CITY OF ALBUQUERQUE

RE: TORRENTINO SUBDIVISION (L-9/D38)
Engineers Certification for Release of Financial Guaranty
Engineers Stamp dated 10/21/2005
Engineers Certification dated 09/16/2005

Re: Torrentino Subdivision Drainage Report
Engineer's Stamp dated 11-29-04 (L9/D38)

Re: Torrentino Subdivision Drainage Report
Engineer's Stamp dated 10-21-04 (L9/D38)

STREET
& VARIES

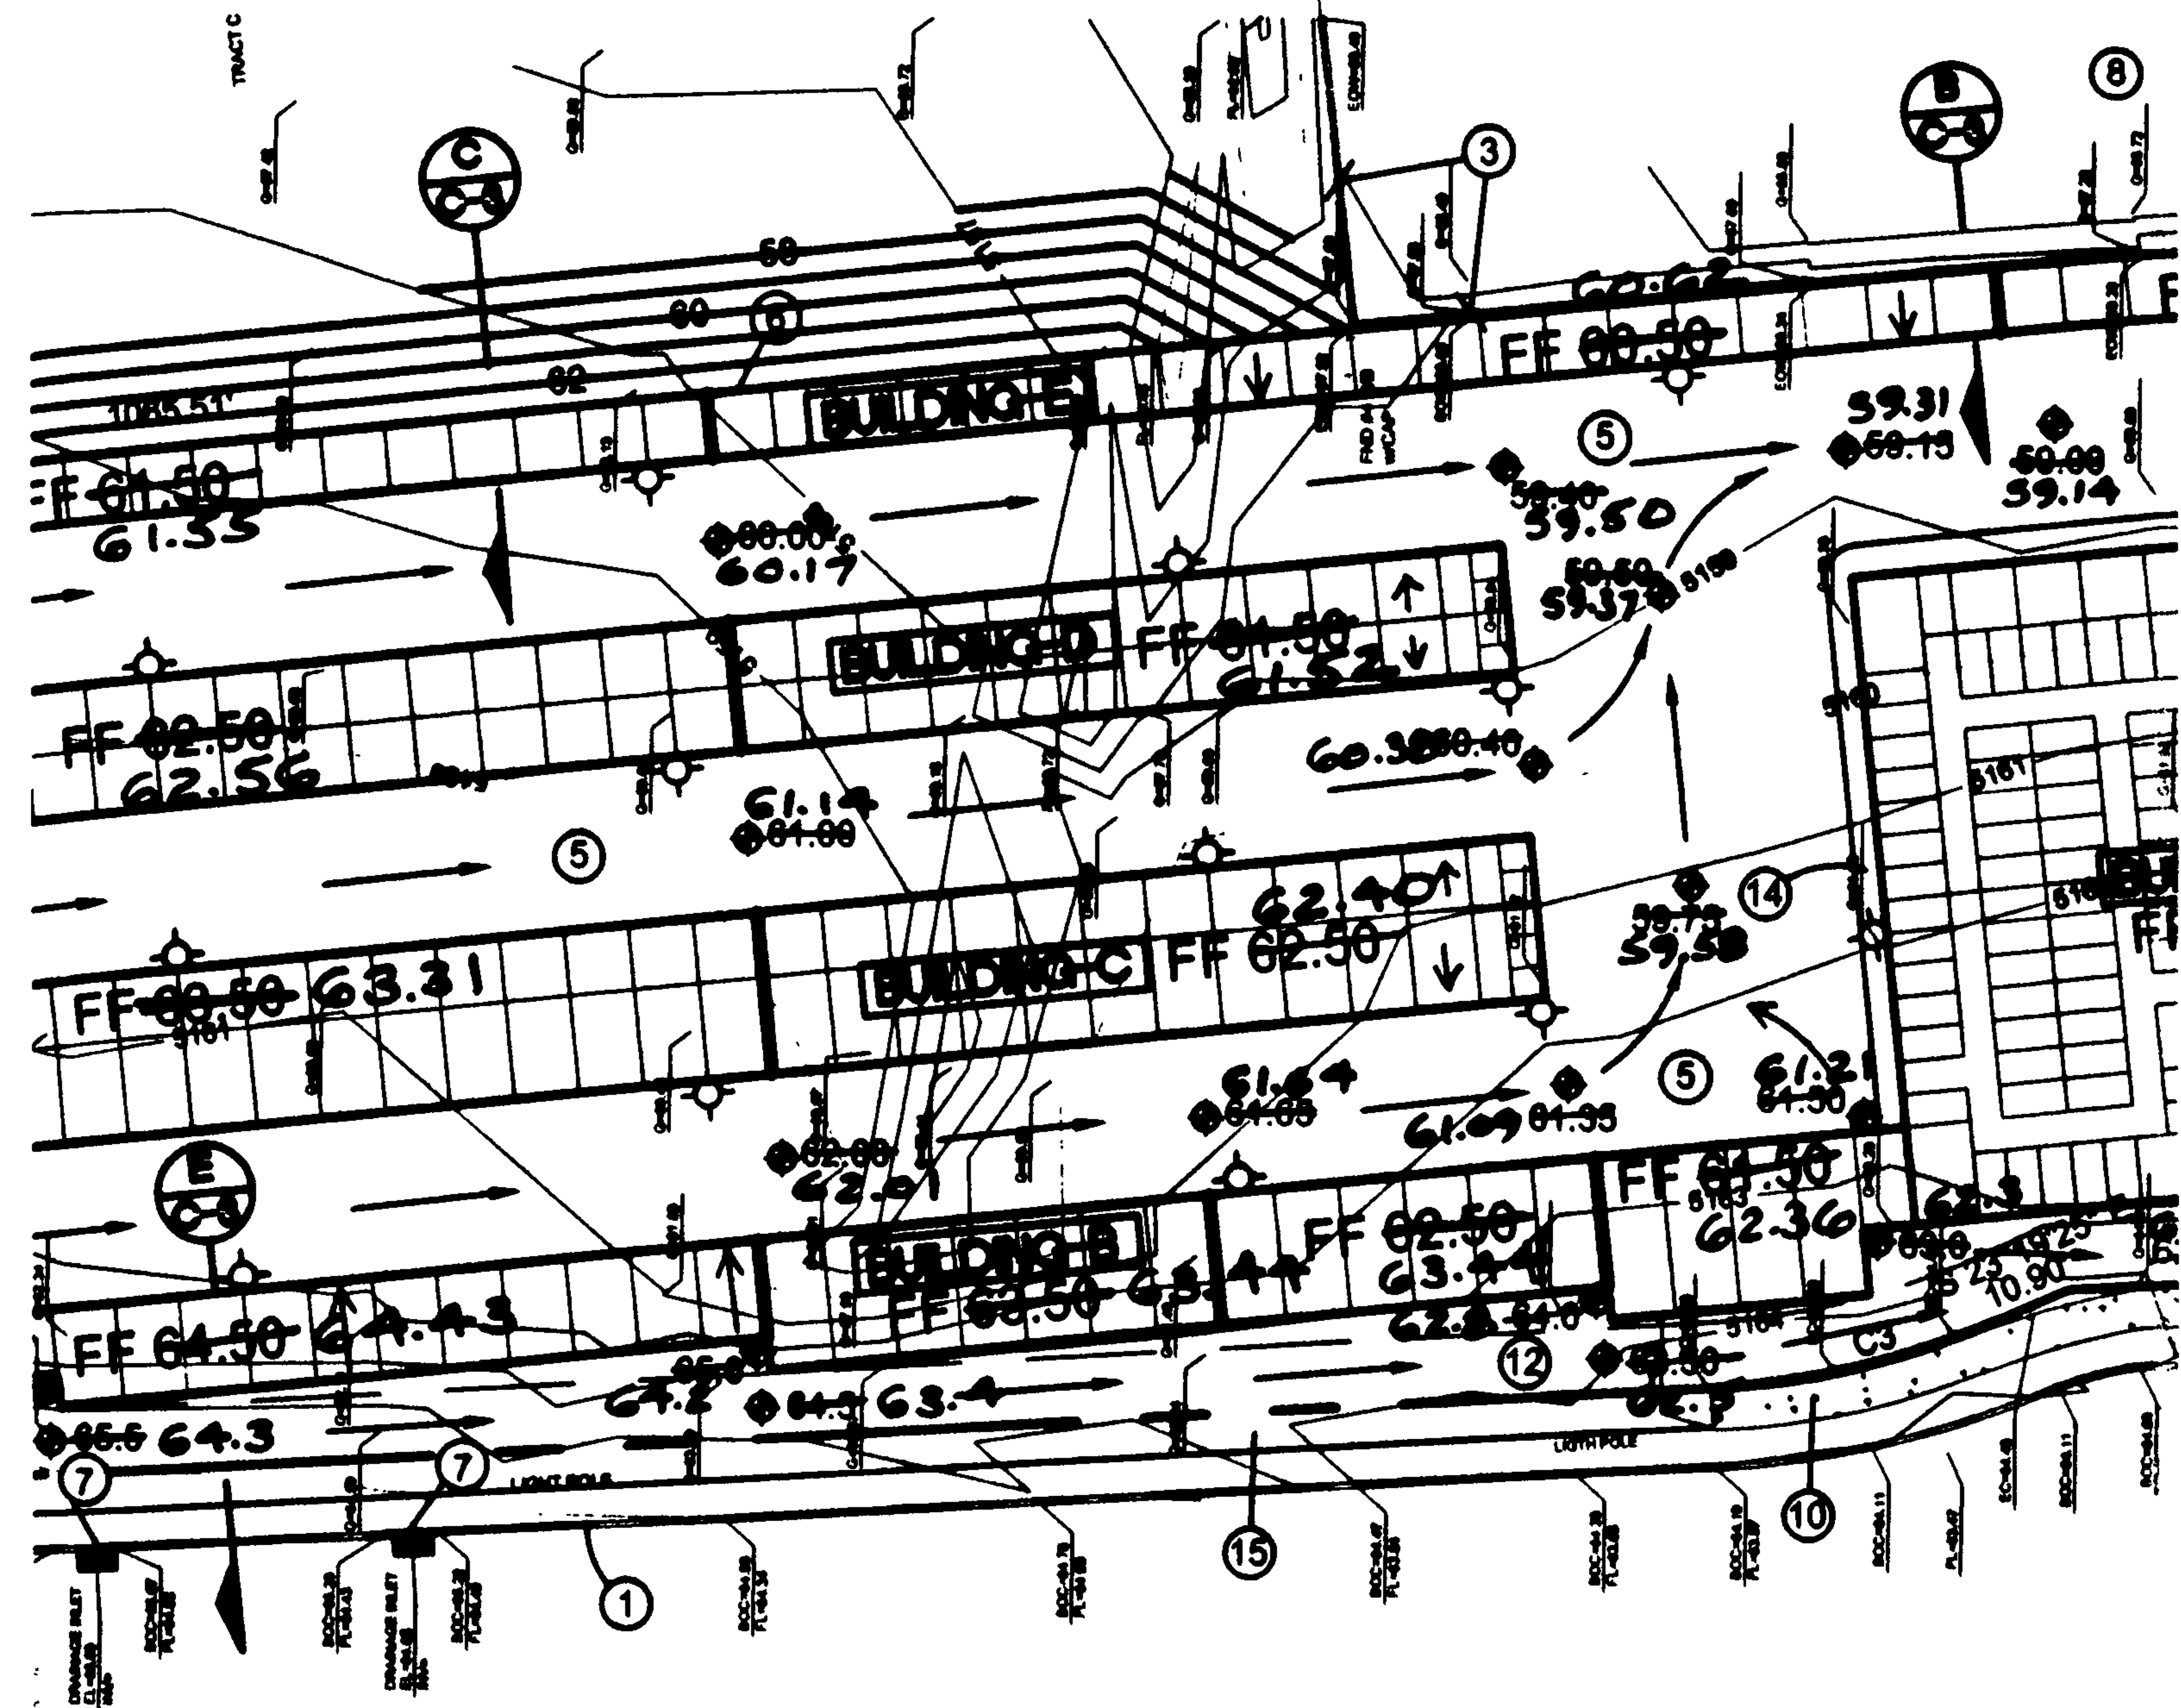
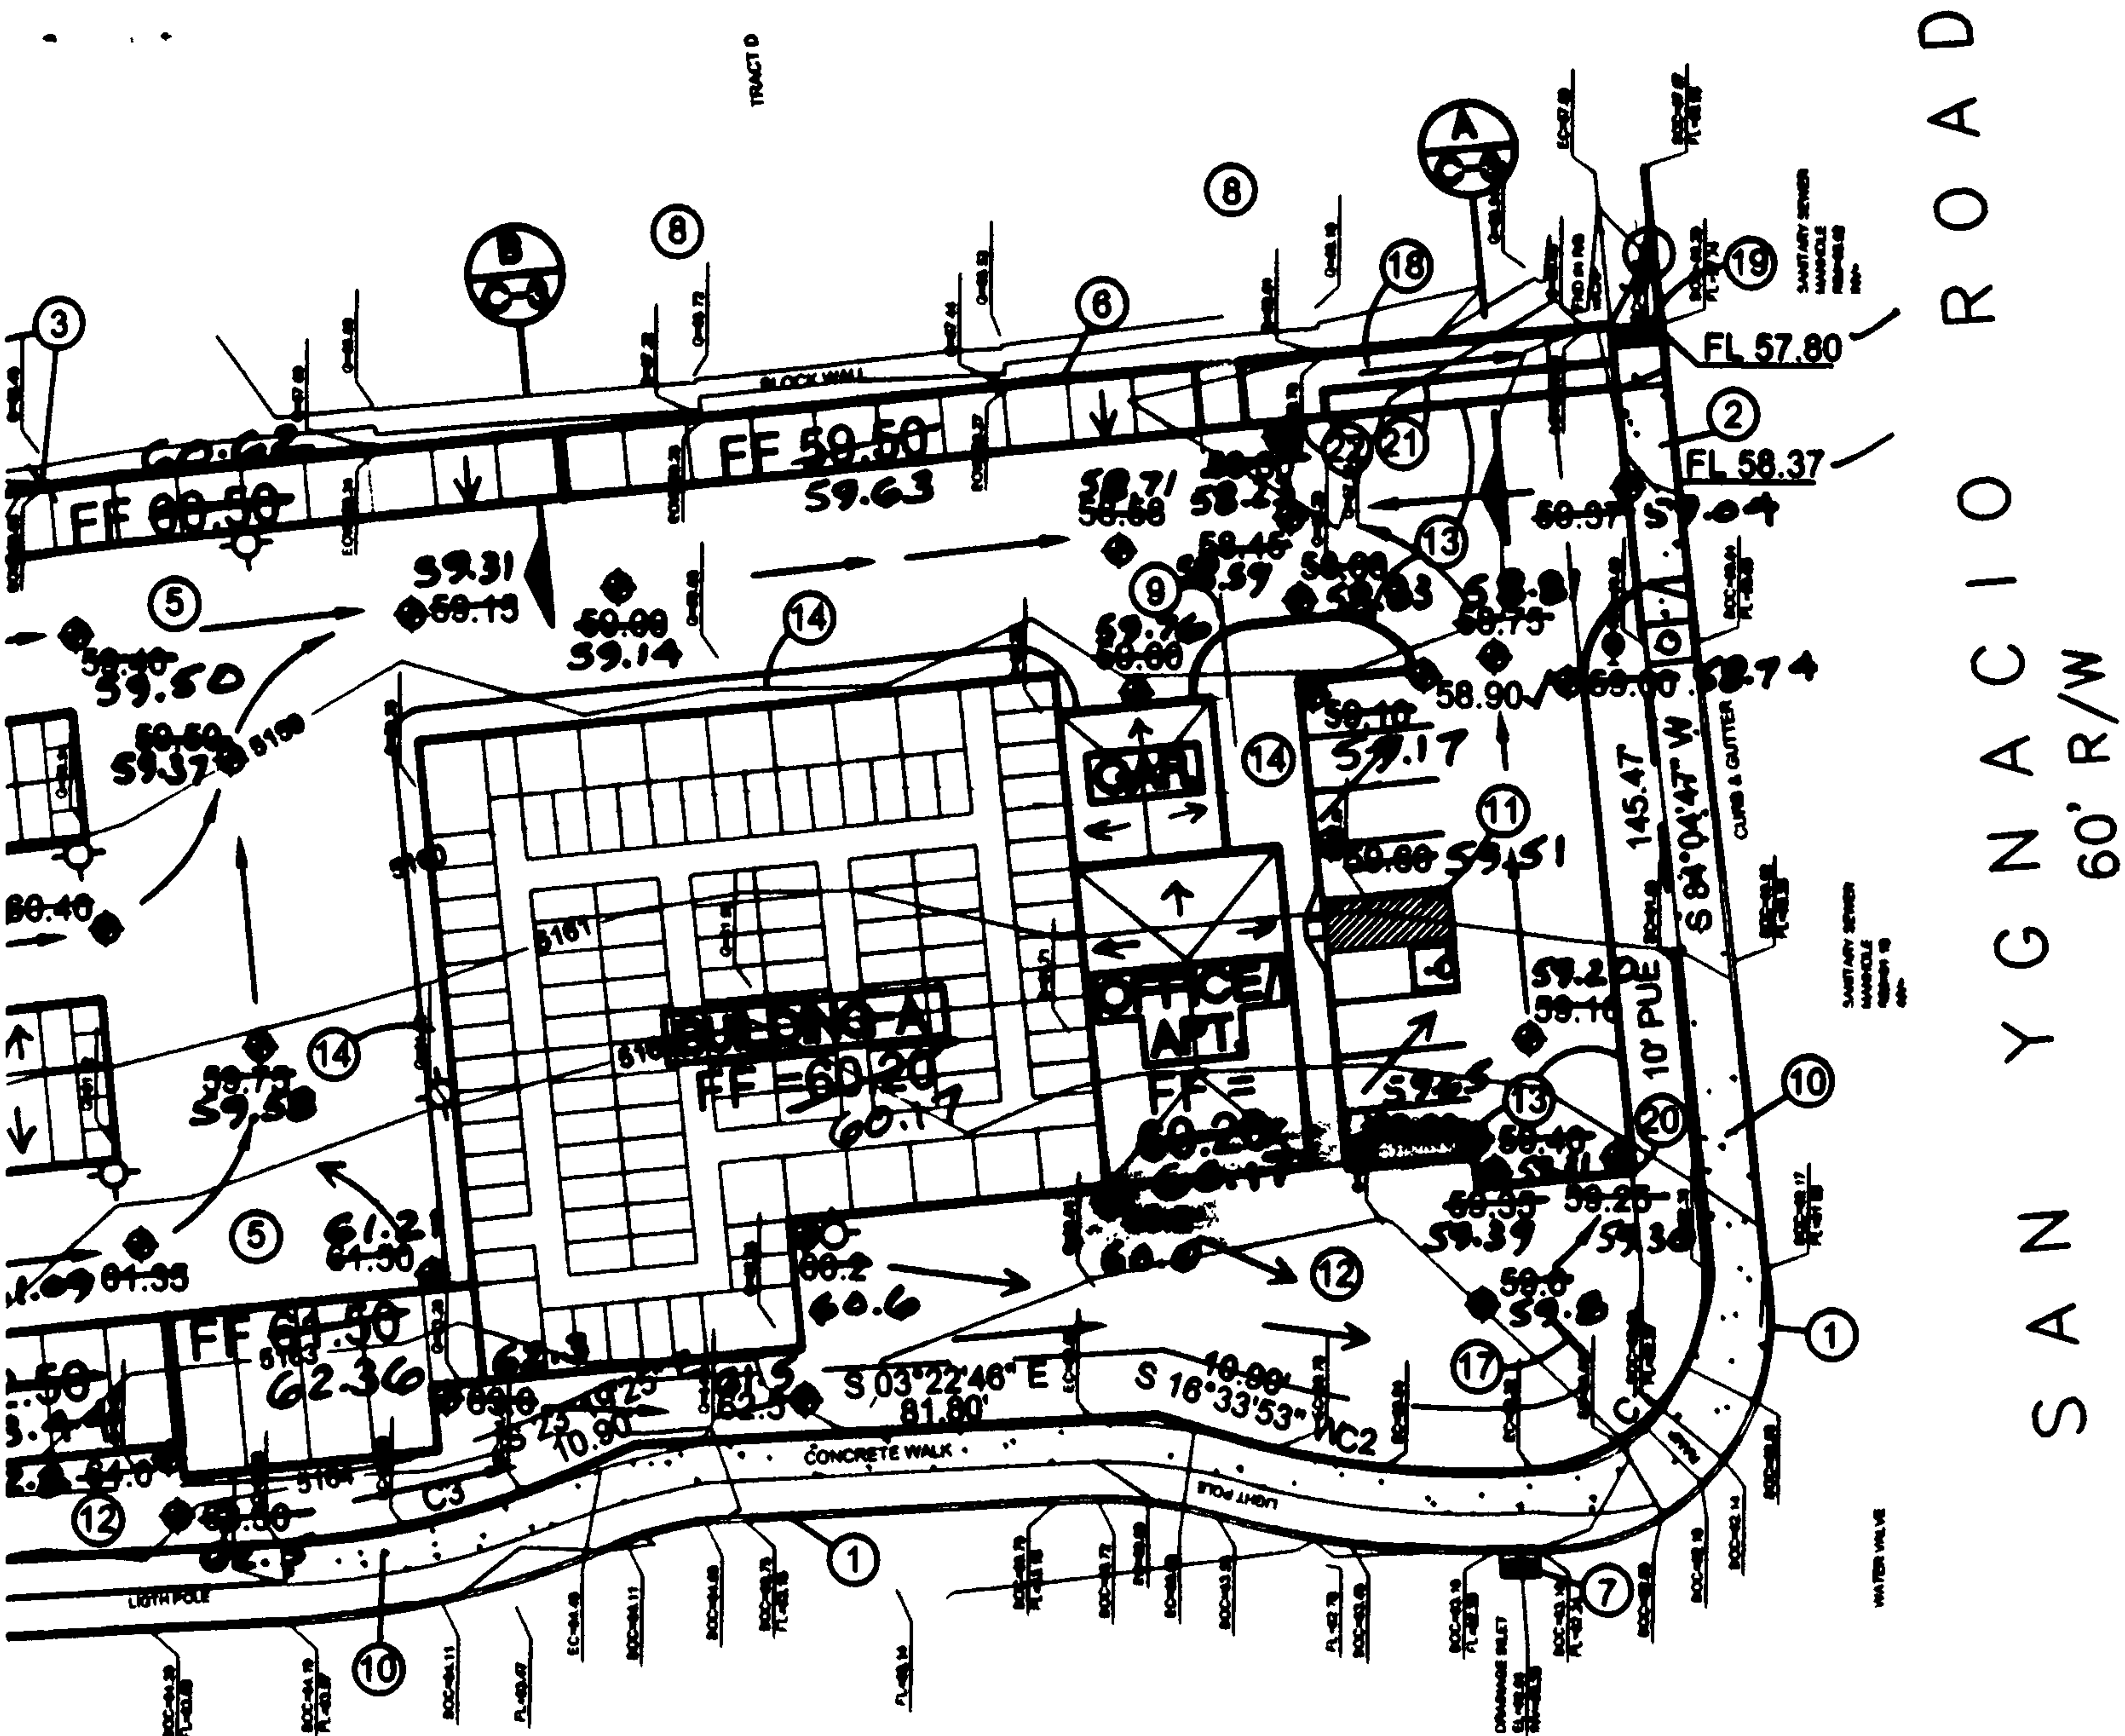
1. The ^{11/29/04}~~Approved~~ Grading and Drainage Plan has an Engineer Stamp date of ~~12/09/2003~~ not 10/21/2005?? as indicated in your submittal. (see attached copy of G/D Report approval letter).
